## Response to Submissions Report for SSD 9452

1 William Street, Sydney  
The Australian Museum, Alterations and Additions

Submitted to Department of Planning &  
Environment on behalf of The Australian Museum

18 January 2019 | 218139

Figure 1 Comparison of Queuing Arrangements

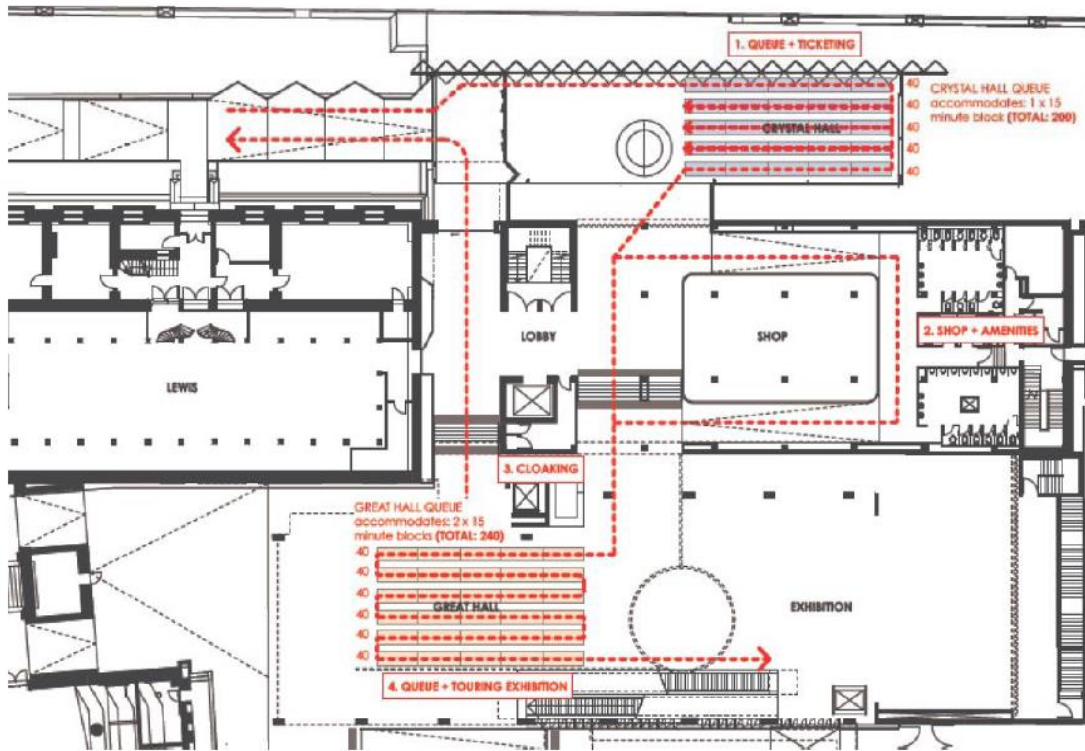
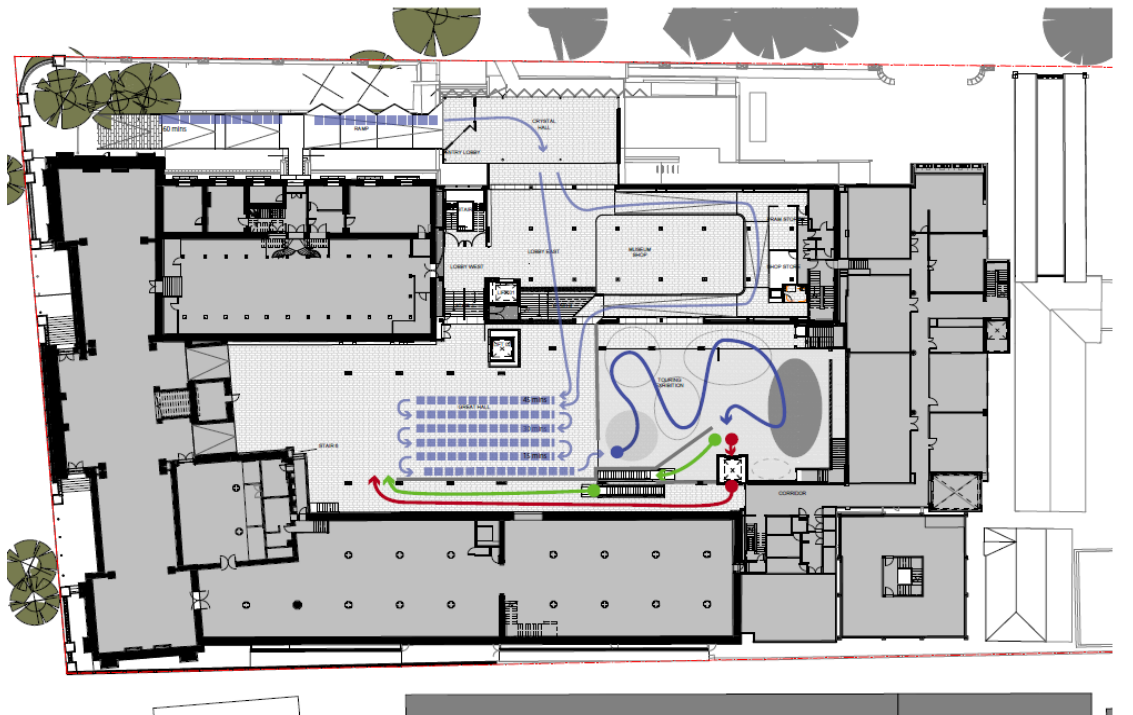
GANSW raised concerns that the proposed works may create conflicts in circulation between different queuing areas, amenities and exhibition areas, and may not provide sufficient area for queuing to match future visitor numbers. Detailed exhibition and circulation diagrams were requested.

The circulation and queuing arrangements for the Museum have been reviewed as part of the amended design and detailed exhibition and circulation diagrams have been prepared by Art of Fact (**Appendix F**). The amended scheme makes better use of the existing space to accommodate the projected visitor numbers whilst removing the need to extend Crystal Hall.

Queuing for groups can also occur in the Crystal Hall undercroft which remains in its current configuration and groups will be welcomed and managed by Museum staff. Through user group consultation, anticipated visitor numbers are accommodated in this space and will be limited to groups. It is noted that groups visiting the Museum require a booking and therefore numbers can be moderated.
